**SITE PLAN REVIEW SHEET
ENVIRONMENTAL VARIANCE REQUEST ONLY**

CASE: SP-2011-0216C

PROJECT NAME: Top Golf

SUBJECT: Top Golf – SP-2011-0216C

**Top Golf
SP-2011-0216C
Existing Site Conditions Fill Area Looking South to North**

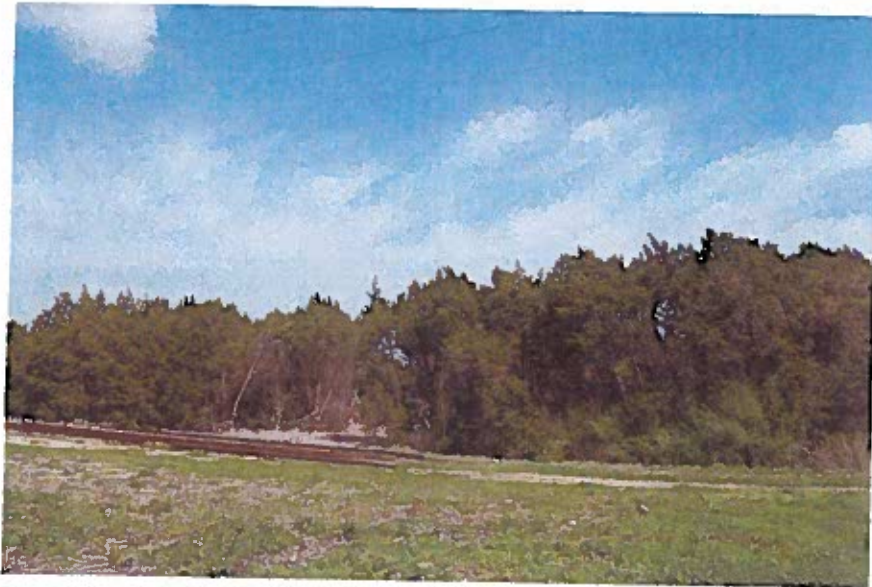
Due to the use and these site constraints we are requesting a maximum fill of 18 feet on the east end of the property to support this development.

Top Golf
SP-2011-0216C
Existing Site Conditions Cut Area Looking South to North

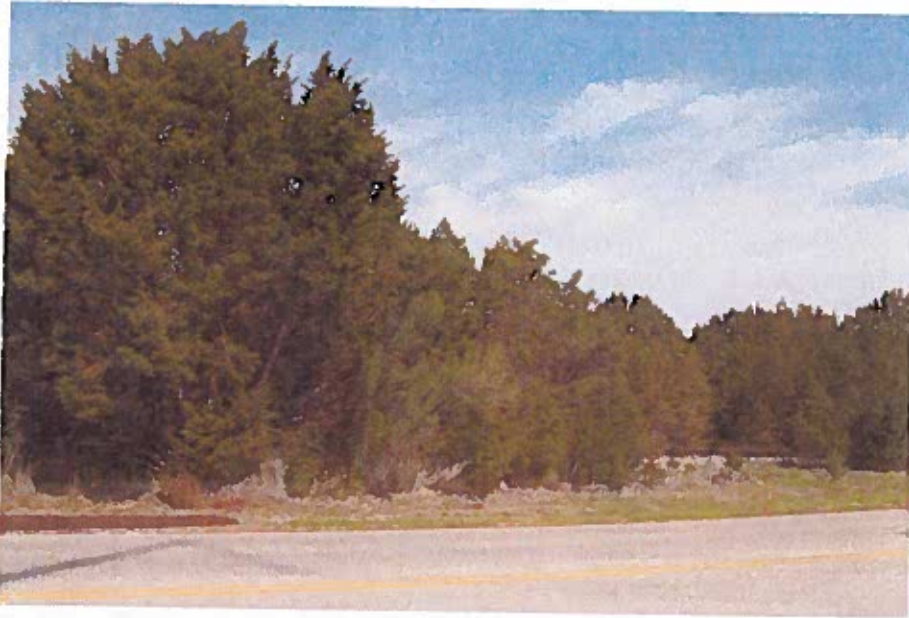
Due to the use and these site constraints we are requesting a maximum cut of 8 feet in the middle of the property to support this development.
